RENESAS TECHNICAL UPDATE

| Product Category | MPU/MCU | | Document No. | TN-RX*-A174A/E | Rev. | 1.00 |
| Title | Errata to RX Family User's Manuals Regarding the Ethernet Controller (ETHERC) | | Information Category | Technical Notification | | |

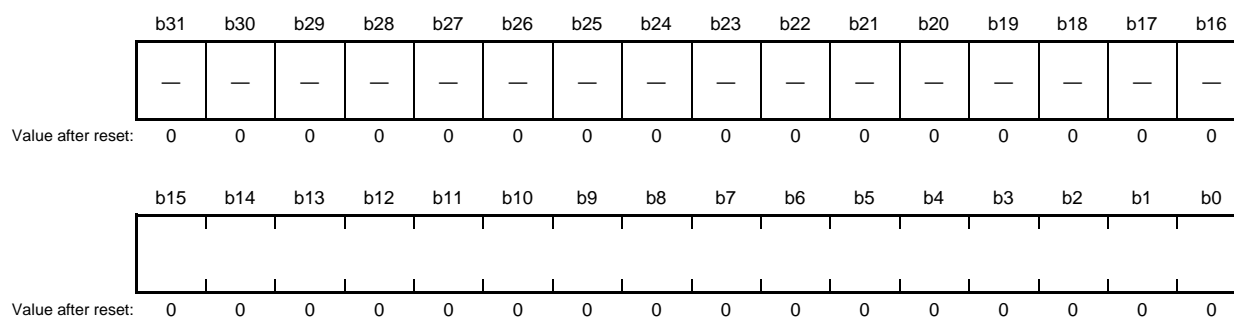
- Page 1533 of 2936

The bit symbol and the bit name of the lower 16 bits in the MALR register in section 35.2.16 are added as follows.

Before correction
